IEEE 1451.4 Standard Working Group
Telephone Meeting, Nov. 2, 2000
Meeting Minutes, issued 11-02-00, Approved 08-23-01

Chair: Steven Chen
Secretary: Paul Hufnagel

Figure 5:1451.4 Transducer interface

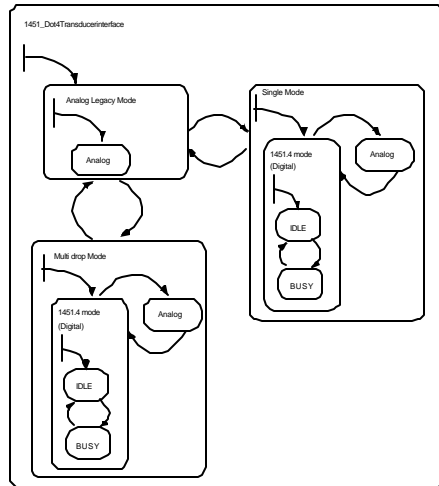
Based on Torben's comments it would seem that starting a multi-drop capable transducer in analog mode would be harmless (analog signals will just linearly add) if more than one transducer is in the line. Starting the transducers in analog mode also preserves compatibility with legacy systems. The key issue is that the transducer behavior is defined by the state of the transducer interface. If the transducer interface is of type 1451.4 then the T-Block will be able to switch to digital mode to further configure the independent transducers in a multi-drop configuration.

Active and passive modes only exist within the analog state. When in digital mode the transducer can be re-configured to be either active or passive and depending on the implementation it might be possible to read the state it's in. We could further specify that when a transducer is removed from the 1451.4 transducer interface it's analog sub state must be active (or the transducer must be reset to it's default state). The standard also mentions that legacy transducers and new 1451.4 transducers can't be mixed on a 1451.4 transducer interface (i.e. legacy system will short when the system attempts to read the TEDS because of negative polarity protection) eliminating the other source of potential conflict.

- b) The material above is to answer questions on the T-Block chapter, which surfaced at the 10-26-00 meeting.
 - c) Starting states for the Transducer Interface should not be confused with those of the transducer.
